# PRODUCT update

So, with the expansion of things, I thought it necessary to put together this little fact sheet to highlight the area that has caused a little concern for some of you - Bay Windows! Most products are still running through the Factory with welded outer frames, but those that are utilising Fully Mechanically jointed Windows have required a little assistance because there is a little additional work that needs to be done by your installers in this circumstance. Due to current manufacturing methods, mechanical outer frames have a very small area of override that creates no issue with normal windows, but does in the case of a Bay configuration. There is a requirement for the installers to cut away this excess area in this circumstance in order for the Bay Pole to be located in the correct position.

**Splayed Bay Pole**

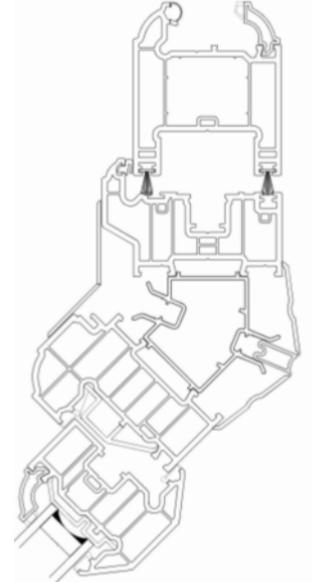
This shows the two windows coupled to a 13 bay pole. In this circumstance, we Supply a flexible angle trim for use between the two products internally. Outside trim is as normal.

**Square Bay Pole with Mixed Product**

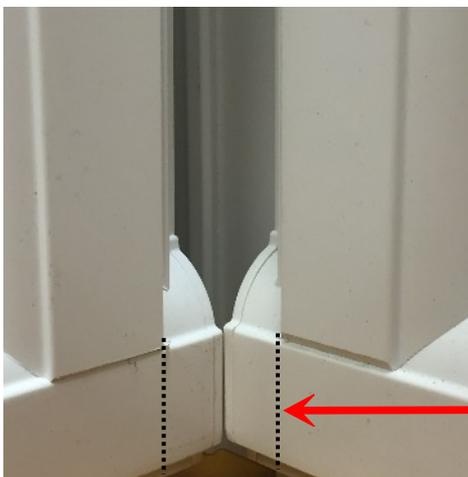
This shows a Revival product coupled to an 85mm Bi-Fold / FlushSASH Door product. Same applies as per the Splayed bay product as the Bi-Fold frame is of the same depth.
